From: Amanda Scholes on behalf of Planning.Responses
Sent: 23 October 2018 13:10
To: Planning Scanning
Subject: FW: FW: RE: Blastreat and Greenhurst, Fitzalan Road, Arundel - Application AB/36/18/PL
Attachments: REV_A_ARUNDEL _ PLANNING 2.pdf; Proposed crossing points and pedestrian visibility splay.pdf; 52C-Ground Floor Plan.pdf

From: Tim Townsend [REDACTED]
Sent: 19 October 2018 14:18
To: Anita Gardner
Subject: Blastreat and Greenhurst, Fitzalan Road, Arundel - Application AB/36/18/PL
Importance: High

Existing BT Depot Splayed Access

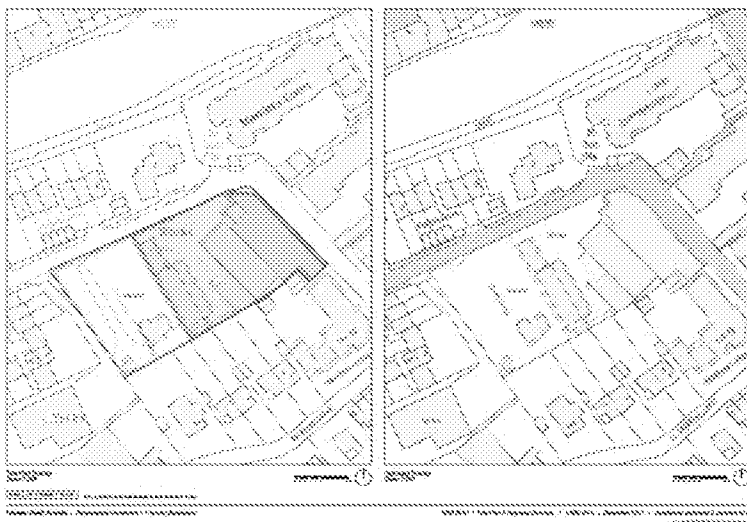
- 1 Stage 1 Road Safety Audit - submitted;
- 2 Neighbouring BT access - I will get our architect to show the BT access details on the Block Plan and Site Plan together with the visibility splay from the proposed access serving the sheltered housing scheme. However, the BT Depot access falls outside of the application site red line boundary. As such the BT access is not affected by the proposed development and the 'flare' remains unaffected as indicated below. The visibility to the BT access is not affected.
